Addendum No. 1
2016 BENNETT REPLACEMENT WELLS

Date: May 13, 2016

Owner: **Town of Bennett, Colorado**

2016 Bennett Replacement Wells - Sheet 3 - ELECTRICAL ONE-LINE DIAGRAM

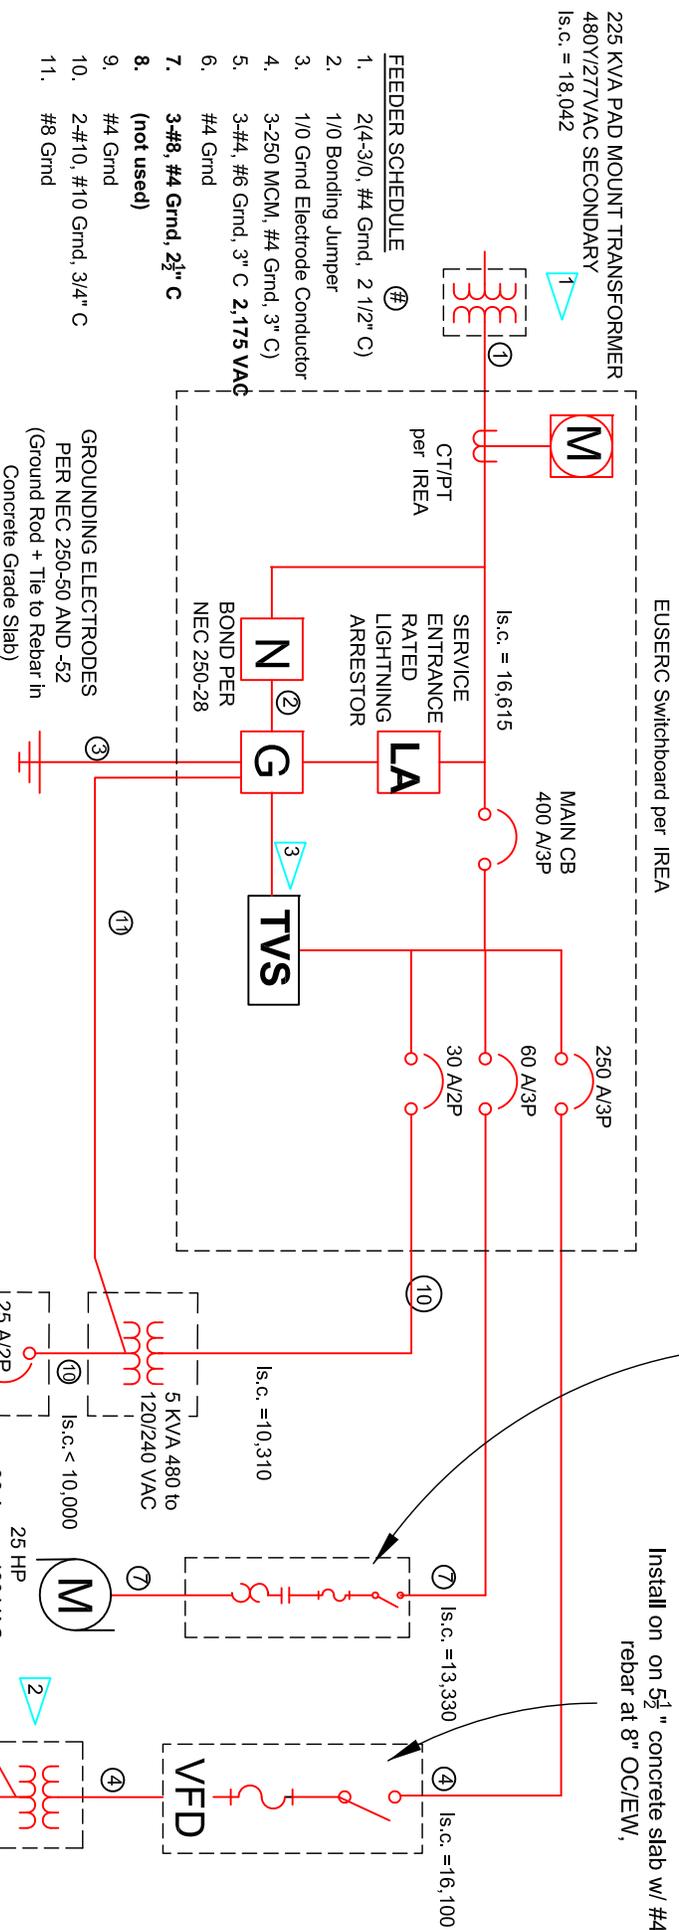
9. Contractor shall supply and install the lightning arrester (LA) in the EUSERC switchboard shown on Sheet 3 of the Drawings. The LA shall be a MacLean Power System "Surge Tec" Z3-480 or approved equal.
